Re: Consultation on an Application

Planning Application Ref: PL/25/1706

Address: Forbury Retail Park, Kenavon Drive, Reading, RG1 3HS

Proposal: Outline application with all matters reserved with the exception of access, for site redevelopment involving the demolition of all existing structures & a residential-led mixed use proposal for up to 700 residential units (Class C3) & up to 3,000 sqm (GEA) of commercial uses (Class E), together with various associated works including replacement pedestrian and vehicle access routes, open spaces, hard & soft landscaping & sewer works, partial basement excavation, up to 130 basement level car parking spaces, up to 53 separate car parking spaces for Class E uses, up to 600 cycle parking spaces & servicing facilities. This application is accompanied by an Environmental Statement.

1.1.4 states:

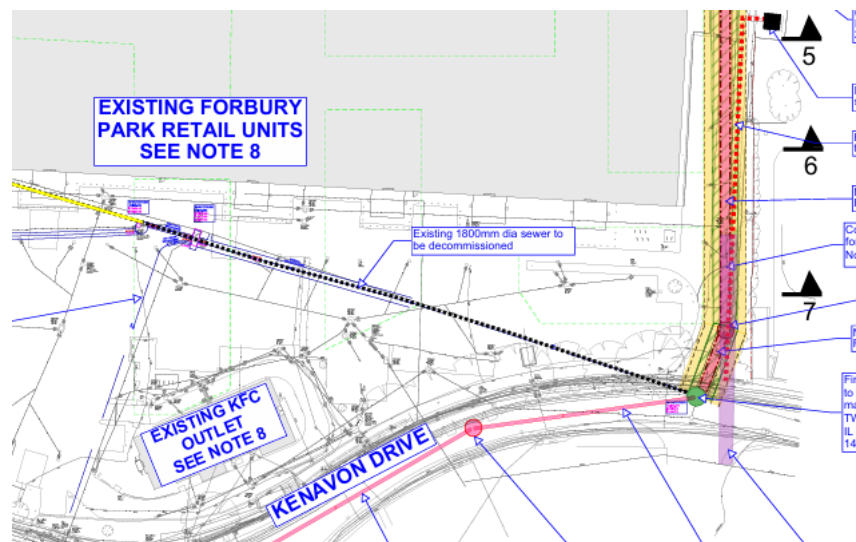
'This report is intended to consider the impact on those trees adjacent to the two proposed access roads only. The remainder of the trees across the site are discussed in a separate Arboricultural Statement, that considers the potential impacts of what are currently indicative layouts, presented on an Illustrative Masterplan. A further Arboricultural Impact Assessment will be submitted for future reserved matters applications, when the details become available for the remainder of the site'.

We do not appear to have this additional AIA?

Design Code - June 2026

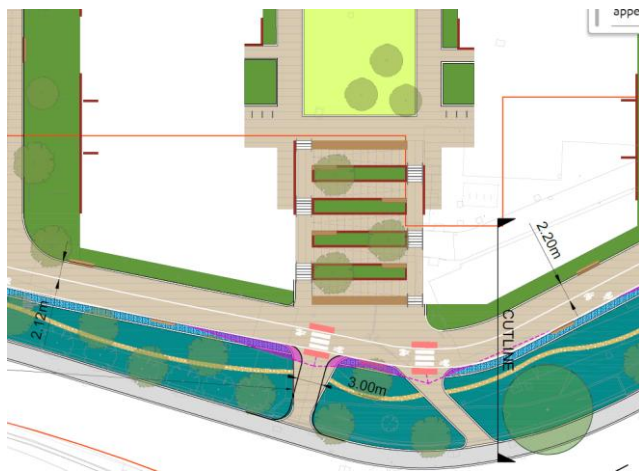
This document is sought for approval, alongside parameter plans, hence should include sufficient detail to demonstrate acceptability at the reserved matters stage. I made multiple comments and suggested amendments in my previous memo.

Changes (those that need a response in bold for ease):

- 3.1 (P.22) – no comment
- 4.1 (P.26) – no comment
- 5.1 Public Realm and Nature - Mandatory Fixes (P.34) – changes noted, incorporating my suggestions
- 5.1 Public Realm and Nature - Mandatory Fixes (P.34) – change to refer to blue & green roofs (as opposed to just blue) noted, as requested.
- 5.2 Public Realm Hierarchy (p.37) – in response to the concern about a minimum 10m for the Plummary Gardens having to accommodate the 2m pavement width (roadside) plus 4m cycle/pedestrian path (shared route) within the site, leaving only 4m to incorporate play, the rill, tree planting; this now states: '*10m minimum width up to 15m excluding the 2m wide pavement to the Forbury Road*'. I note this now excludes the roadside pavement hence that a min 10m (and up to 15m)

will provide for the 4.5m pedestrian / cycle way (width stated in 5.3), so actually leaving 5.5-10.5m to incorporate play, the rill, tree planting.

- 5.3 (P.38) – reference to ‘greenways’ (which was undefined) has been changed to ‘the links and connections’ (as described earlier on the same page)
- **5.6 Tree Planting (p.45) – I previously commented that the statements on the TPO Plane trees and retained trees were confusing, when considered against what other submissions showed. Reference to the retention of any of the TPO Plane tree is not omitted, which is not positive.**
